N4010A-03

S E R V I C E N O T E

N4010A Wireless Connectivity Test Set

Intermittent Power-Up Issues Or Error Messages

Figure 1: Connector P4 On The RF Assembly

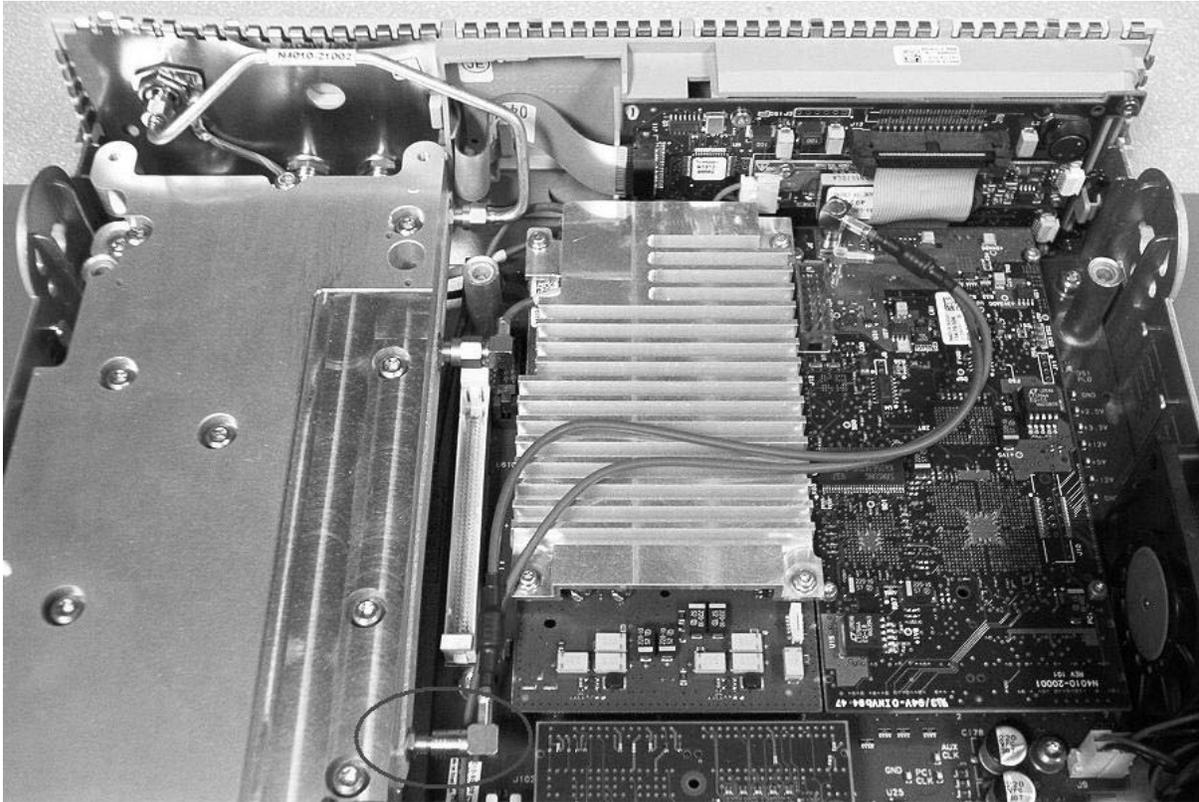
1. Loosen the five captive screws on the bottom of the instrument.
2. Remove the top cover from the instrument.
3. [Option 102/103 units only] Disconnect the semi-rigid cables from ports 2 & 3 of the RF Switch.
4. Lift the hinged deck assembly into the vertical position.
5. Disconnect the cable attached to P4 on the RF Assembly (refer to Figure 1).
6. Inspect both the RF Assembly and the cable for signs of damage (refer to Figures 2 and 3).

If there are signs of damage to either the RF Assembly or the cable, then both must be replaced. Once the instrument has been re-assembled, it must be fully re-calibrated.
